TO: Planning & Zoning Commission  
FROM: Heather Milway, Village Planner  
THUR: Charity Jones, AICP, Planning & Economic Development Director  
SUBJECT: Case 15-08 Estates of Montefiori Preliminary Planned Unit Development  
DATE: June 11<sup>th</sup>, 2015

Case No. 15-08  
Project Name Estates of Montefiori Preliminary PUD and Rezoning

**Estates of Montefiore**  
 Lemont, IL

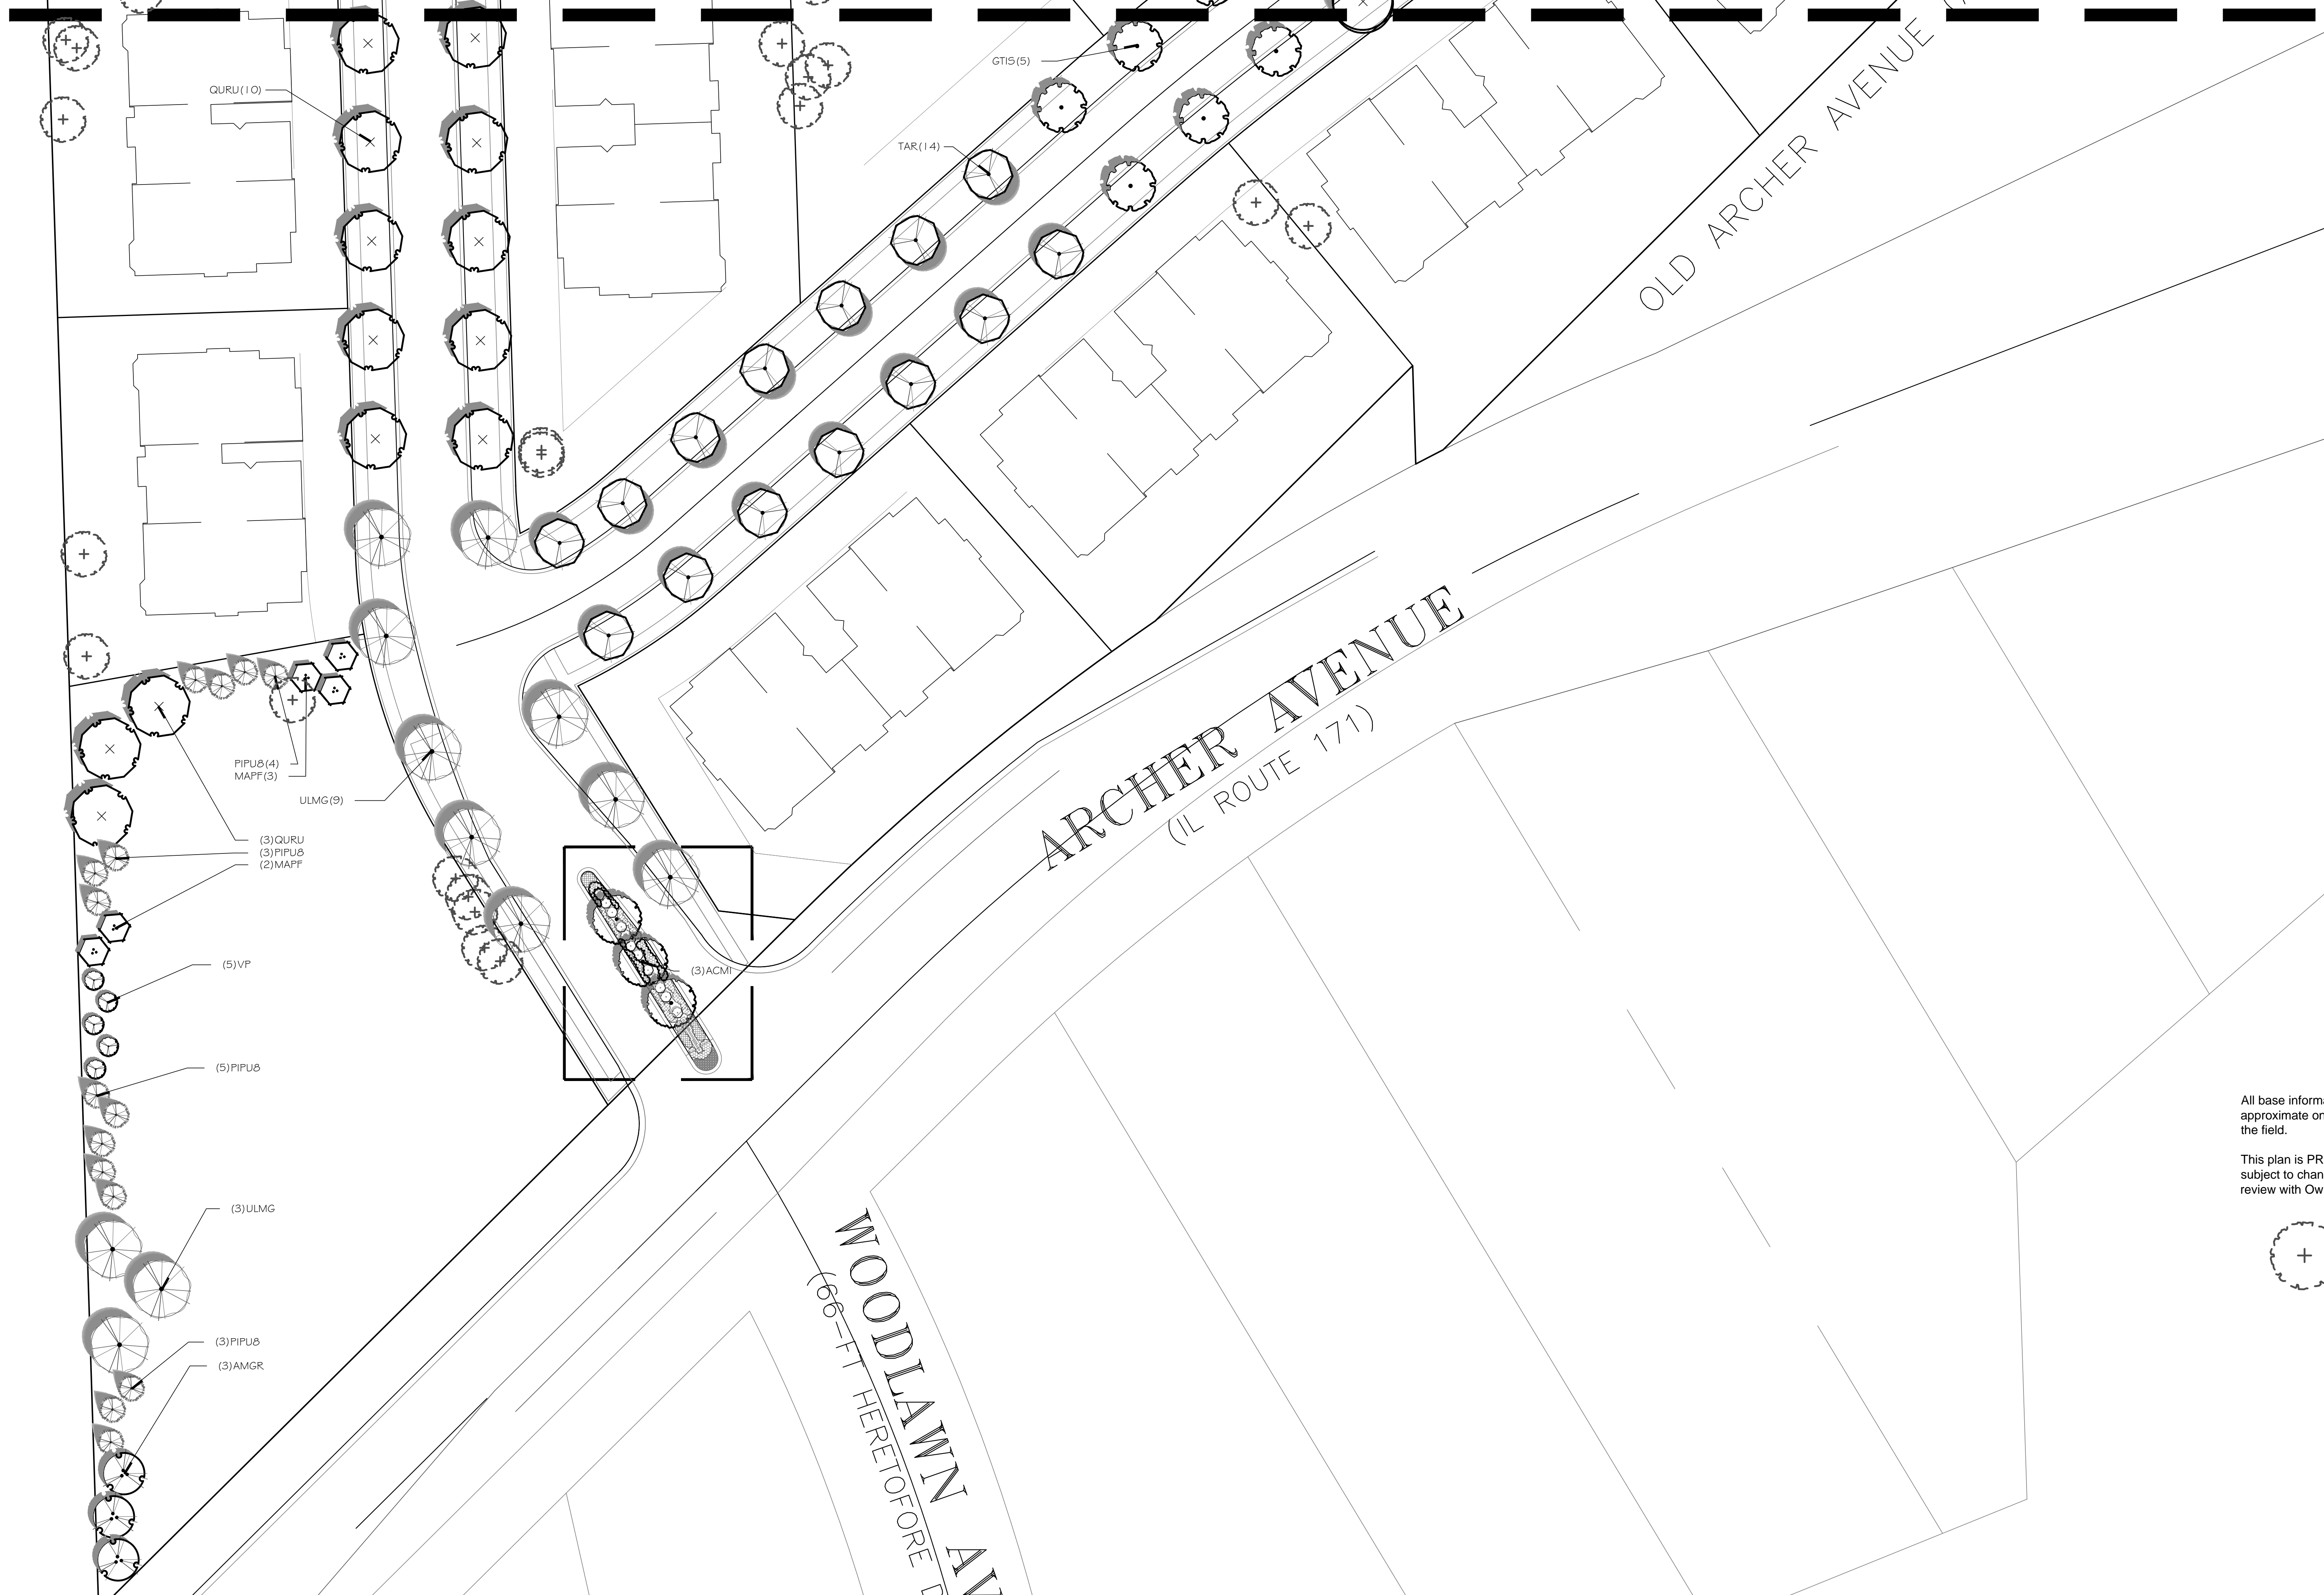
**Landscaping.** The Village Arborist has reviewed the proposed plans and comments that the tree survey was not complete and thus the request for a tree preservation waiver cannot be reviewed as the condition, age, and species of the existing trees cannot be examined to determine which are suitable to preserve or be mitigated for, if removed. Additionally staff recommends that tree preservation be used to achieve the goal screening the ComEd ROW from the townhomes and town homes from single family on lots 25-31. The landscape plan was also not complete and could not be reviewed for consistency with the UDO. The landscape plan and tree survey must be resubmitted to be fully evaluated. The Village Arborist's full comments are attached.

The Landscape Plan by Wingren Landscape dated 5.19.15 is a Preliminary Plan. It does, however, include some of the existing trees that are to be saved. The plan includes this Note: "Final decision of existing trees to remain will be based on health, species, and condition of the tree as well as final engineering". This comment is more in line with Chapter 17.20 of the Lemont Unified Development Ordinance. This approach is certainly more appropriate at this stage of the process than a "full waiver for the preservation of trees on the property".

This exhibit is titled "Tree Preservation Plan". There is no Tree Preservation Plan. There is an Existing Tree Survey that includes tag numbers from 191 through 3263. The tree survey also includes a tree data listing format for tree species, size, and condition. The survey includes this data information for about 7% of the 3,702 trees that were tagged. This lack of information is another indication that a "full waiver for the preservation of trees on the property" is not appropriate at this stage of the process.

5. Revise the landscape plan to include proposed tree preservation measures. Additionally, include more landscaping behind the proposed townhomes on "Tuscany Ln" to screen the units from the Com Ed right of way.

PLAN 391001

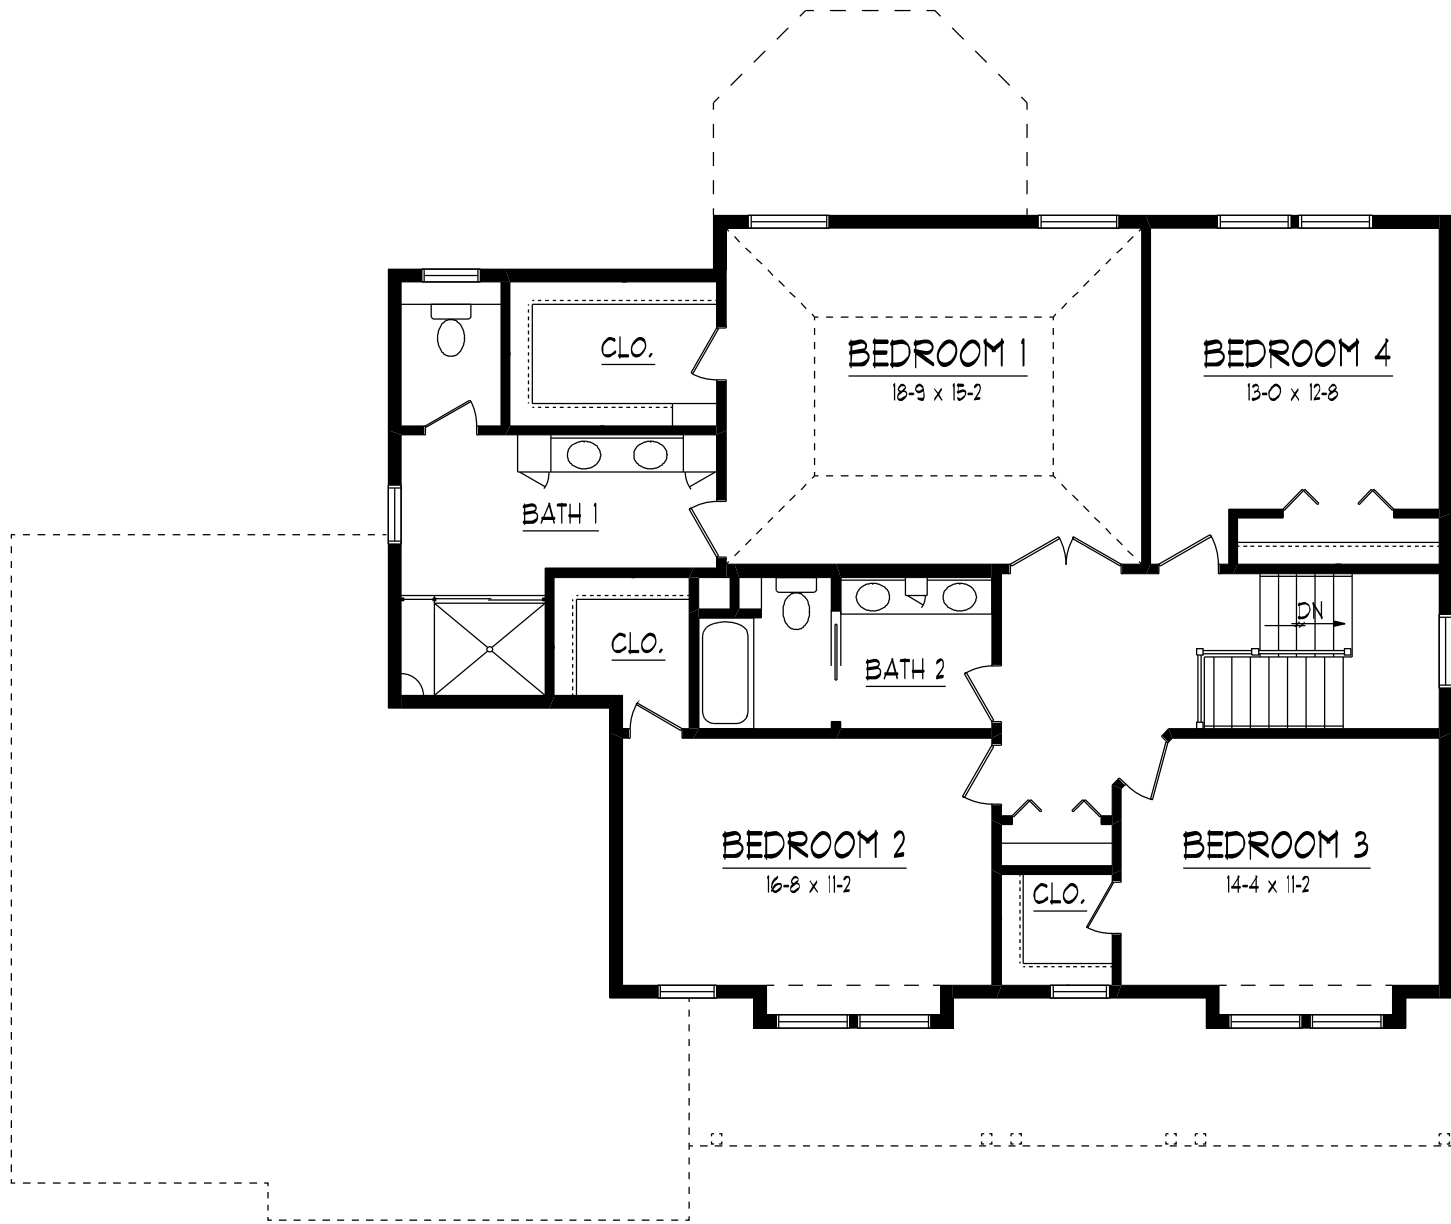
While the submitted plans for the single family homes show a substantial amount of brick, the applicant requests the flexibility to substitute siding for all brick. Staff finds this acceptable for house types 391001, which is similar to a craftsman style home that would traditionally have wood siding. The substitution of siding for the remaining house may be appropriate, but staff does not have enough information on the proposed design of the homes at this point to make a determination. Staff recommends that the applicant prepare elevations of each of the house types with siding to allow for a more thorough review of the appropriateness of all siding.
